MODELS AFFECTED

1948-49 "60"
1948-50 "75"
1948-50 Land-Rover

ENGINE

CAUSE Condensation inside sparking plug cover.

Fig. 1 Modification to sparking plug cover.

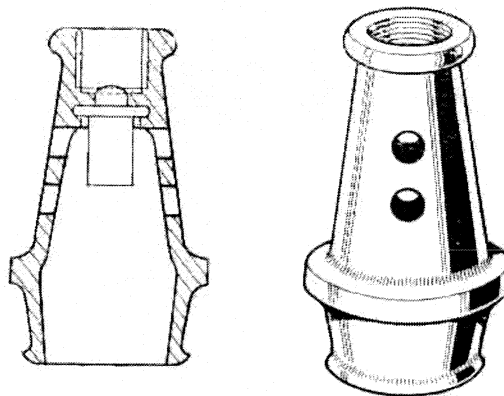
1. ENGINE MISFIRING
2. SPARKING PLUGS FAULTY

Examination of alleged faulty sparking plugs returned to us, and investigation of complaints of misfiring and kindred troubles, have shown that only in rare instances are the sparking plugs actually defective. In almost all such cases, the fault lies in condensation inside the plastic plug cover; it should be remedied as described below. It must be emphasised that Lodge H.L.N.R. plugs are fitted as standard on these models and must be used for all subsequent replacements.

- REMEDY.
1. Remove the sparking plug covers and dry thoroughly.
 2. Drill four $\frac{3}{16}$ in. (4,8 mm.) holes in the cover as shown at Fig. 1. The lower holes

are drilled on the same centre line as the existing $\frac{1}{8}$ in. (1,6 mm.) ventilation hole; the upper holes should be positioned at $\frac{3}{8}$ in. (9,5 mm.) centres above the first holes.

3. Remove, clean and dry the sparking plugs; re-set the gaps as necessary and replace.
4. Replace the covers with the holes lying to front and rear, *i.e.*, with the holes parallel to the engine centre-line. In this way the air flow assists in evaporation of any condensation.
